COMMUNICATIONS - GOGO AVANCE L5/GARMIN INTERFACE

700 (Citation Longitude)

Provides the ability to reset or turn on/off GOGO Avance L5 internet from the Garmin Touch Controller (GTC).

Figure 1. GOGO Avance L5/Garmin Interface Electrical Wiring Modification (Sheet 1)

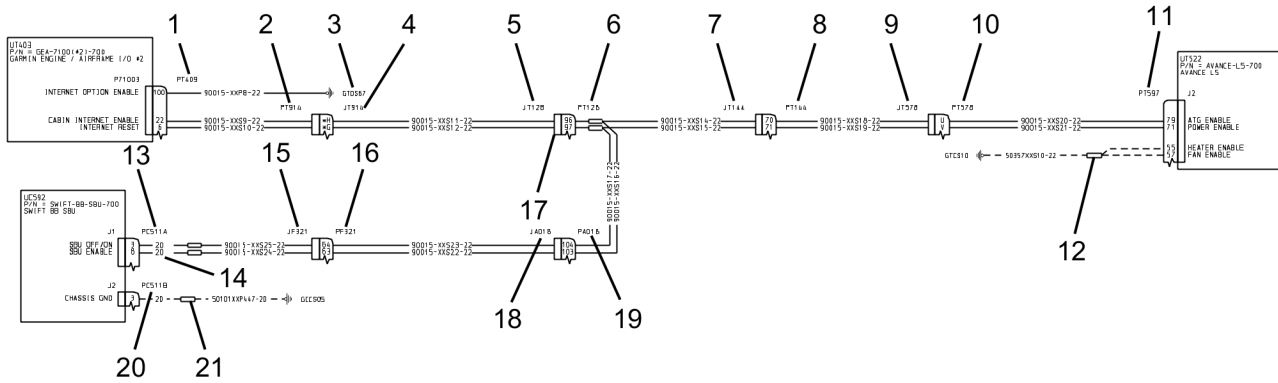
2. Do the wiring modification.
 - A. (Refer to Figure 1, Sheet 1.) On aircraft -0001 thru -0030 do the wiring modifications per wire diagram.
 - B. (Refer to Figure 1, Sheet 2.) On aircraft -0031 and -0032 do the wiring modification per wire diagram:

Before Modification
 Aircraft -0001 thru -0030

After Modification
 Aircraft -0001 thru -0030
